The dataset proposed by Ferrari et al. provides spatially resolved fields of atmospheric and hydrodynamic variables for the caldera region within Deception Island, based on a long-term one-way coupled numerical experiment. I appreciate the clear presentation of the dataset, the quality of the figures, and the logical flow of the manuscript. Furthermore, I find it commendable that the authors dedicate significant attention to sub-scaling atmospheric models, nesting multiple grids and models, and rigorously calibrating and validating various variables across different spatial and temporal scales. These are efforts often overlooked in research that is primarily question-driven, yet they deserve recognition in their own right. This dataset holds considerable potential for future applications, particularly in the validation and comparison of remote sensing products. As sensor resolution continues to improve, it could become increasingly valuable for comparisons with water levels from radar altimetry and SAR-derived wind, waves and currents fields.

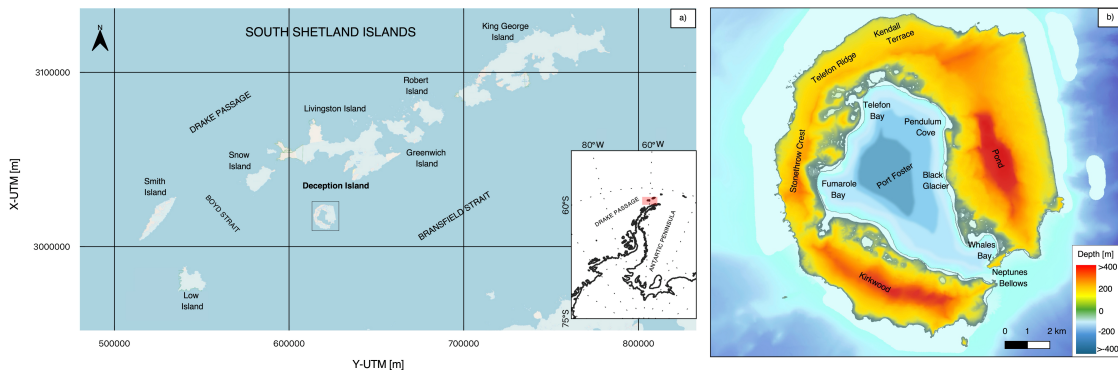
Figure 1 and lines 69–72: The bathymetry inside the caldera is a bit under-described. While the narrow passage depth is mentioned, the central caldera basin appears to exceed 100 m depth based on the figure, yet this is not stated in the text. Please include this detail in the description of the case study and consider refining the color classification in Figure 1 to better represent bathymetric variation.

"The inner basin of Port Foster reaches depths exceeding 100 m, with some areas approaching 180 m, as also depicted in Figure 1. This relatively deep and enclosed environment plays a key role in modulating internal circulation and wave attenuation."

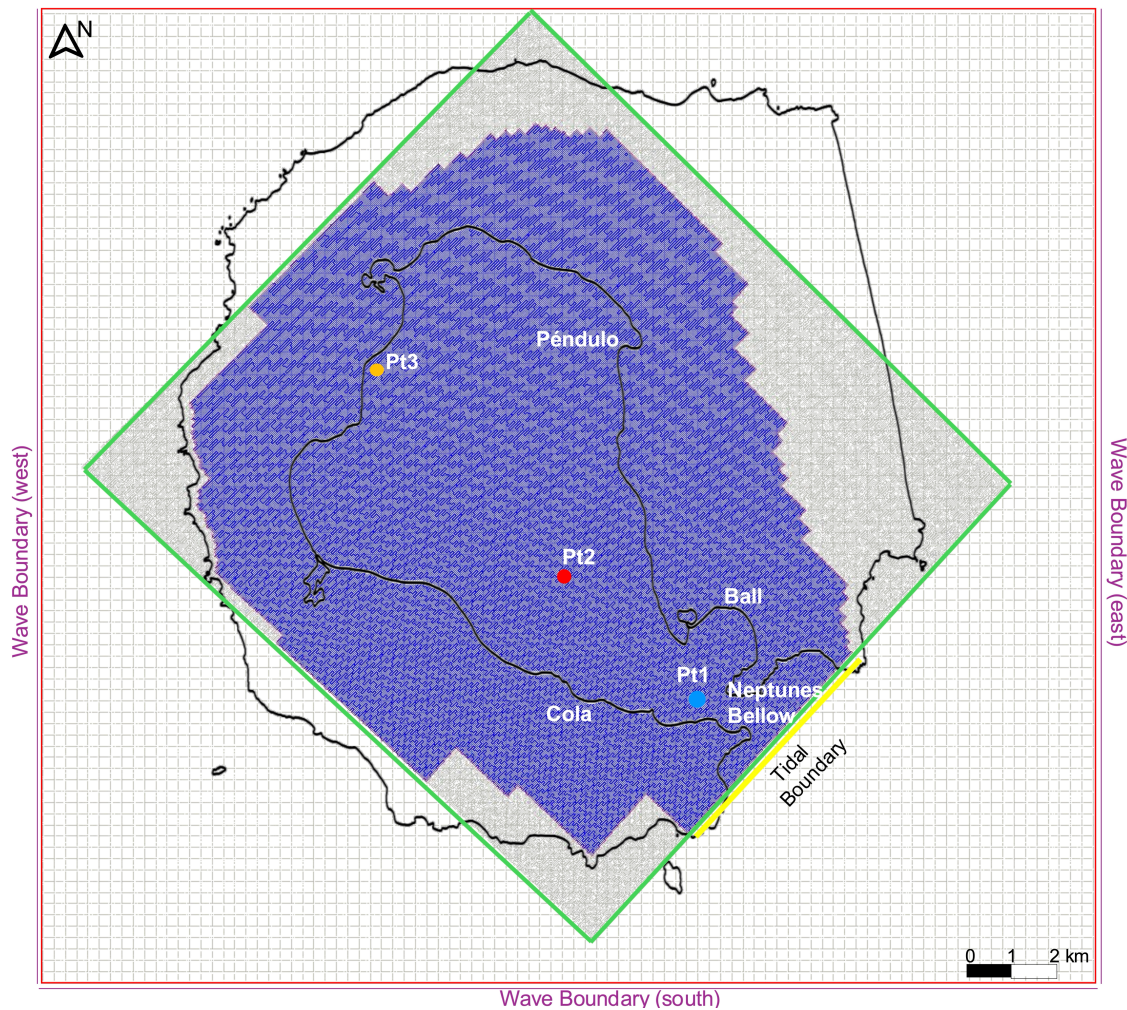
Figure 4 Please label the observation stations (Cola, Péndulo, Ball, Neptuno) directly in the figure as they are referred to in the text. Additionally, the green polygon is hard to distinguish—consider using a more contrasting color.
